Comments by James Adcock on Docket UE-210220 ELCC
Docket number of this proceeding: UE-210220
Commenting party's name: James Adcock, Electrical Engineer
The title and date of the comment or comments:

Comments Related To Puget Sound Energy's Effective Load Carrying Capability Estimates And Use In The Company's All-Source Request For Proposals, Docket UE-210220

9/14/2021

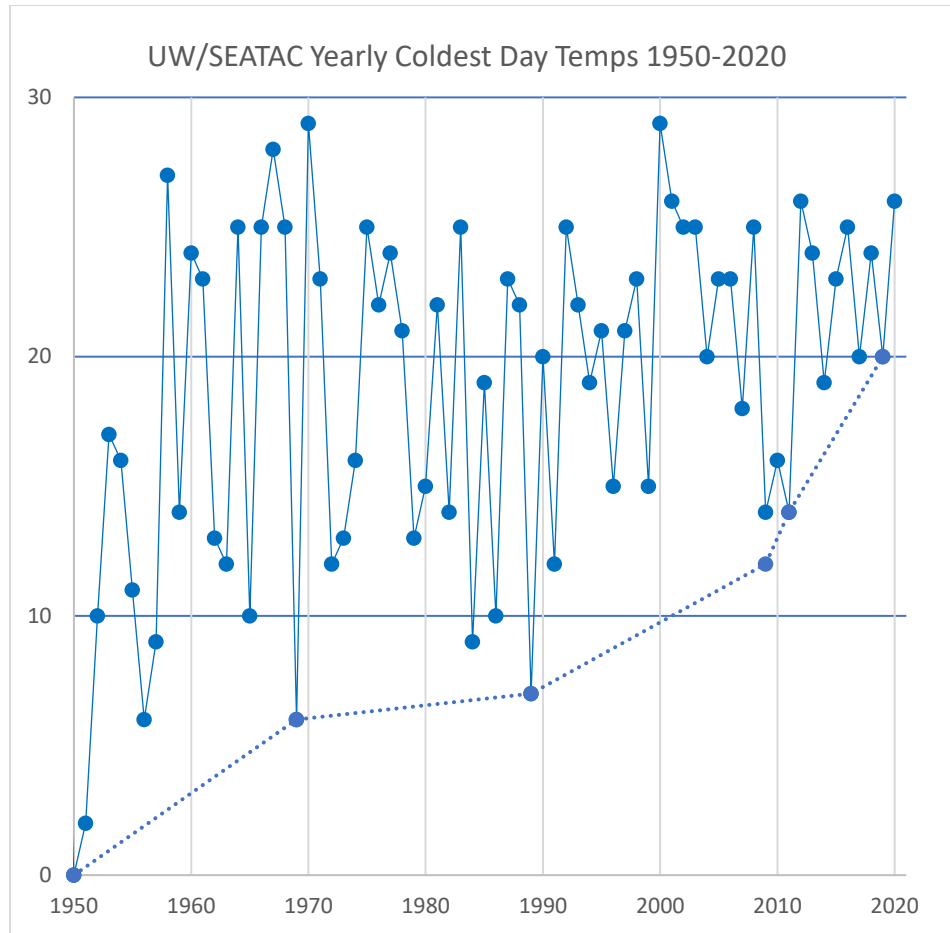
But are these new Peaker plants even necessary? E3 finds that they are not necessary – i.e., that PSE is exaggerating their LOLP by literally 10X by using fake analysis – by using extremely cold winter day historical data from the first part of the previous century – up to 100 years before the period of analysis! [More discussion to Follow] These extremely cold winter days no longer exist. They have gone away due to Climate Change, as the following chart demonstrates:

Where each dot shows the coldest temperature in Fahrenheit of the coldest day of each year, and the dotted line connects the “Coldest of the Cold” temperatures in each running 20-year period corresponding to a 5% LOLP – “Once in 20 Years” calculation. PSE’s modeled “Loss of Load” clearly is strongly related to such extremely cold days, which is why E3 finds that 94% of PSE’s modeled “Loss of Load” occurred due weather conditions which existed in the early half of the previous century, and only 6% in more recent decades after Climate Change has made coldest winter days much more mild.

One can clearly see that extremely cold days have “gone extinct” with Climate Change – “Coldest Winter Days” used to be as cold as zero degrees F., now the “Coldest Winter Days” have become a much more mild 20 degrees F. This in turn represents a reduction in “Heating Degree Load” of 20/65 – a more than 30% reduction in winter load due to cold temperatures! Yet PSE continues to use weather data even prior to 1950 – back to the early 1930s!

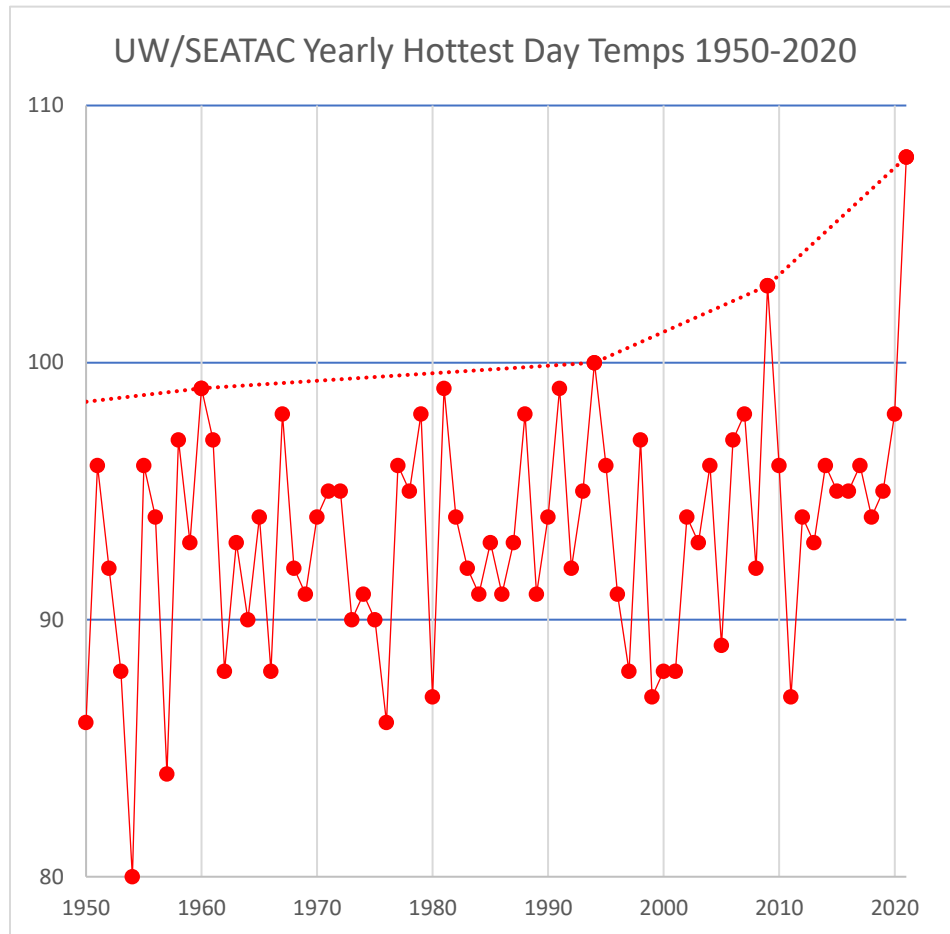
Conversely, Hottest Summer days have become increasing hot increasingly faster, due to Climate Change:

PSE needs to acknowledge that Peak Capacity Shortfalls are now driven by Summer needs, not Winter needs – PSE’s recent actual “emergency” shortfall conditions have happened in the Summer. And PSE needs to get rid of any continuing “Seasonal Swap” contracts – where PSE sells Summer Capacity to another utility in exchange for receiving Winter Capacity. Such “Seasonal Swaps” no longer make any sense, nor does it make any sense to build additional Peakers to continue to support such Seasonal Swaps.

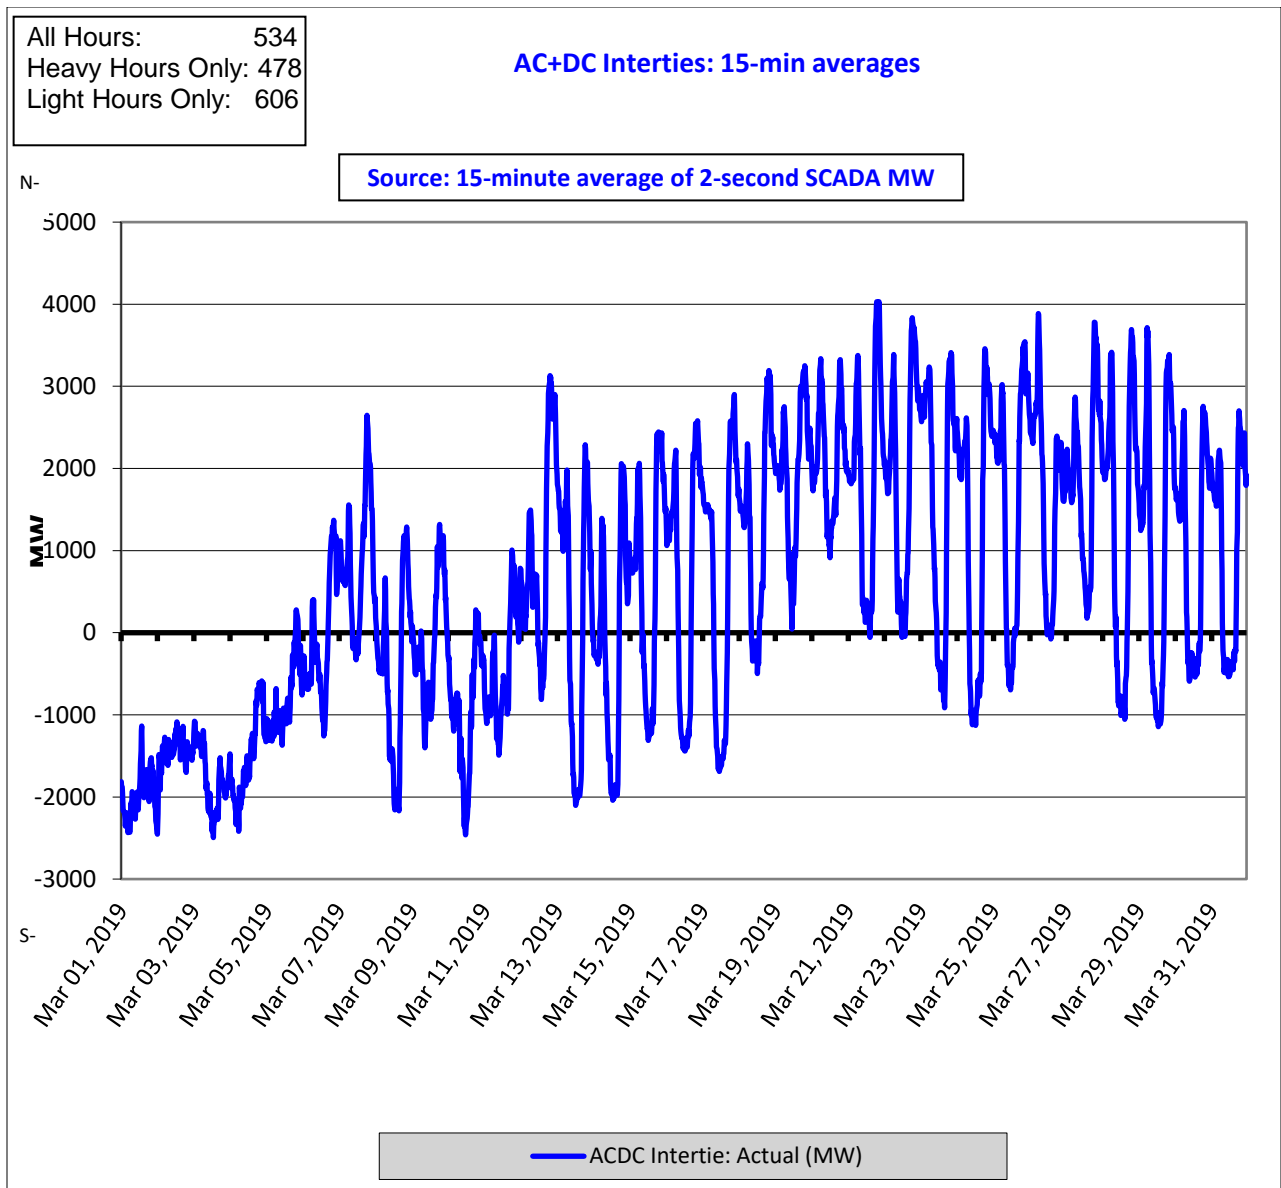
The following chart from BPA, which shows Californian Exports/Imports [from Mid-C] during a recent *Rare* cold snap shows these patterns. Positive numbers represent Exports from the PNW to California. Negative numbers represent *Rare* imports from California to the PNW – a condition which almost never exists – 99% of the time “we” – the Pacific Northwest – are exporting power to California – huge amounts of power, averaging 7000-9000 Megawatts. IE the PNW almost always has huge excesses of power! This plot demonstrates the *extreme rare* opposite to the rule – where the PNW is importing a few thousand Megawatts from California. And in turn the first couple days of the year do show *the rare condition* where power was being imported continuously from California. Even on this rare very-cold month all the other days show the typical daily pattern of fluctuation – with twice daily peaks of capacity need in the morning and early evening – a daily pattern of fluctuation where Batteries can indeed in reality contribute to ELCC by (as previously suggested) being used to shave peaks and fill valleys. And as is well-known in the Electrical Utility business, smoothing out load in this manner is extremely effective in using existing resources – including Transmission – more effectively. Which in turn is why Commercial

and Industrial customers have traditionally been charged a large premium based on their patterns of peak usage. In summary, batteries *do* make a meaningful contribution to ELCC *except* during those extremely rare periods of time when energy is being imported *continuously* for several days from California.

In addition, this plot shows the falsity of assumed limitations on imports into the PNW, where PSE has adopted NWCouncil/RAAC false assumptions of very limited availability of imports. On the contrary, California has huge excess generating capacity in the winter available for import to the PNW, as this plot shows, where 2500 Megawatts are being imported from California – no muss no fuss – contrary to the NWCouncil/RAAC / PSE assumptions of limited availability of imports to the PNW.
